PIC32MX534/564/664/764 Family Silicon Errata and Data Sheet Clarification

The PIC32MX534/564/664/764 family devices that you have received conform functionally to the current Device Data Sheet (DS60001156K), except for the anomalies described in this document.

FIGURE 1: EXTERNAL COMPARATOR SCHEMATIC EXAMPLE

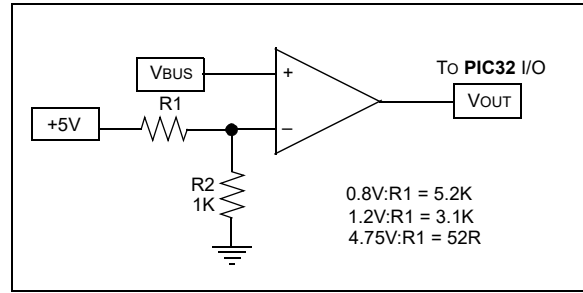
When the USB model is configured for OTG operation, it may not recognize all required OTG voltage levels on VBUS pin.

Use external comparator circuit to detect OTG specific voltage levels on VBUS pin.
